Stormwater Site Plan/Report

PUYALLUP MEDICAL OFFICES

Revised: 6/11/2024

FES Project #23062

STORM ANALYSIS
PUYALLUP MEDICAL OFFICES
DEVELOPED CONDITIONS

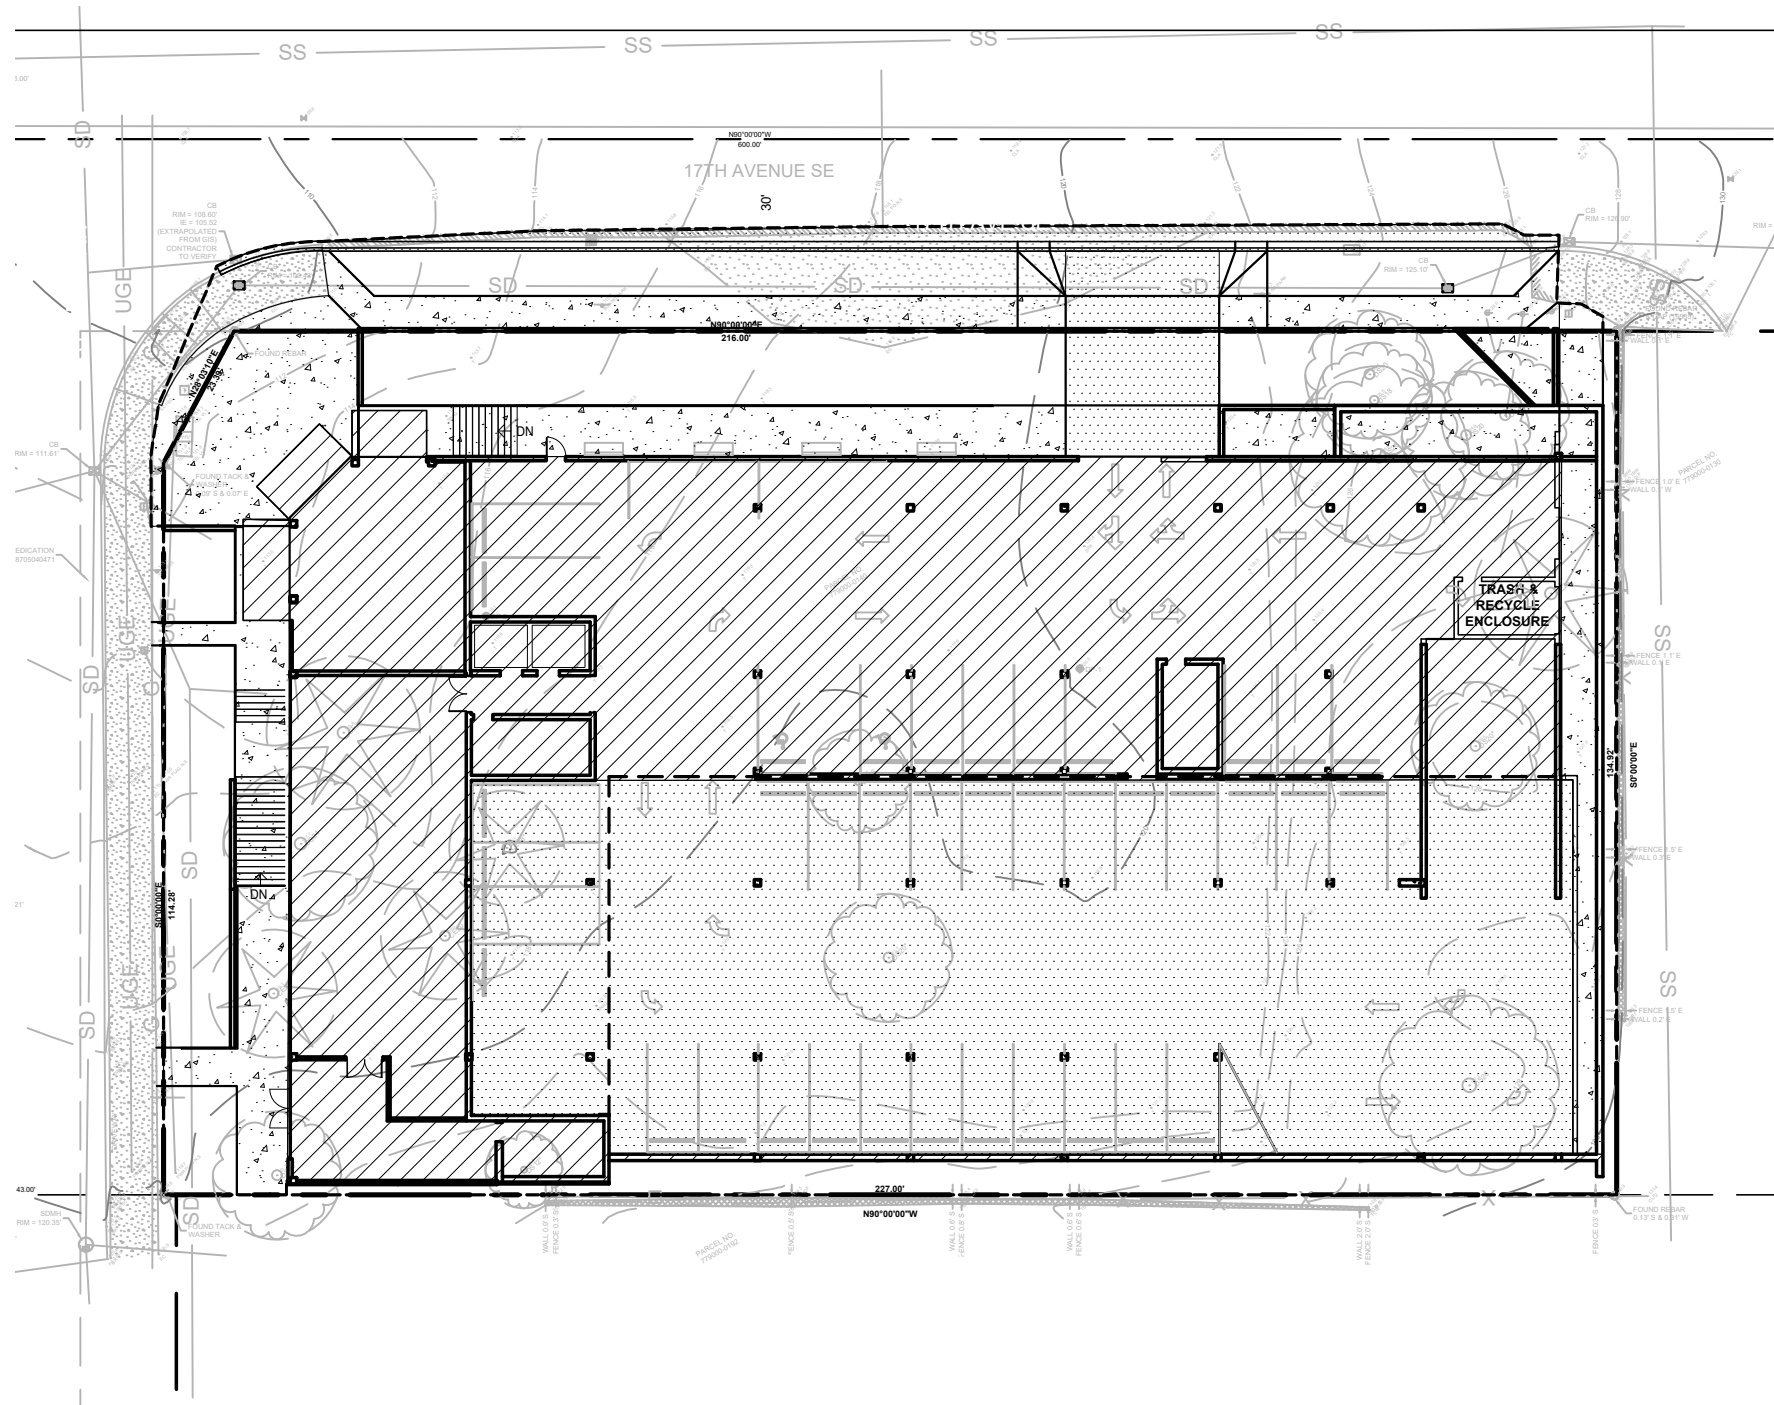
Include a bypass basin for the frontage improvements along 17th Ave SE. [drainage report, pg 17]

The post-developed conditions for the map on page 17 state the pervious area is 0.262 acres. Revise accordingly. [drainage report, pg 17]
